Question. 1 *The July 2003 GSI report indicates that the attenuation mode of sound waves becomes cylindrical at a distance equivalent to the water depth below the source. Why did the committee use the intermediate 15 log R in Table 2.3 instead of the spherical (20LogR) and then the cylindrical (ie 20 LogR and 10 logR).*

Question 2 *Provide the rms values for the GSI source in both vertical and horizontal directions.*

Figures 2 and 3

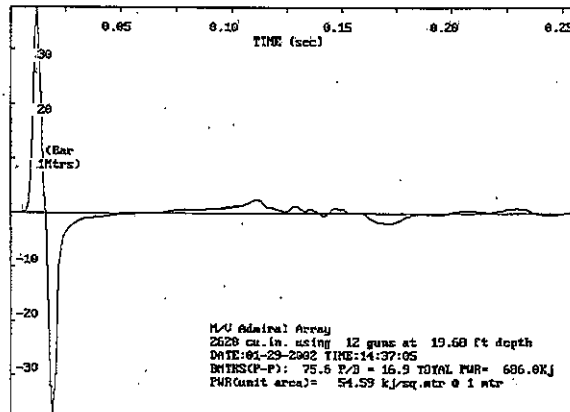
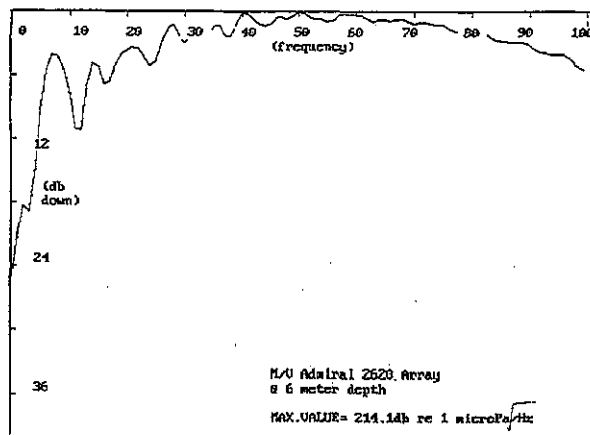
In the attached document, I've estimated that for a typical on-axis air gun pulse will have a rms attribute 5db less than the peak and therefore 11 dB less than the peak - peak attribute. The uncertainty in estimating rms values without the actual data in digital form is due to the identification of the actual duration over which one forms the integration. A figure of 5dB difference will result if the airgun signature is perfectly triangular in form whereas an actual airgun signature (on axis) is more "peaky" in shape resulting in a greater difference between the peak and the rms with the rms being up to 12 dB below the peak attribute. (see Figures 2 and 3 from Canning and Pitt 2002 report attached).

The sentence:- "A titre d'exemple - 214 dB." could be misconstrued. This is a comparison of a spectrum peak level and pressure peak that is incorrect. The 214 dB figure refers to the maximum value of the Power Spectrum of the airgun pulse on axis as provided by GSI. See attachment.

From Environmental Assessment Report, GSI Gulf of St. Lawrence M/V Admiral, prepared by Canning and Pitt Nov 2002. This shows the peak-peak pressure of 75 bm = 257.5 dB//1µPa@1m = 0-Peak pressure of 251 dB//1µPa@1m. When converted as a spectrum the peak of the spectrum is quoted as 214 dB//1µPa/Hz^{1/2}@1m.
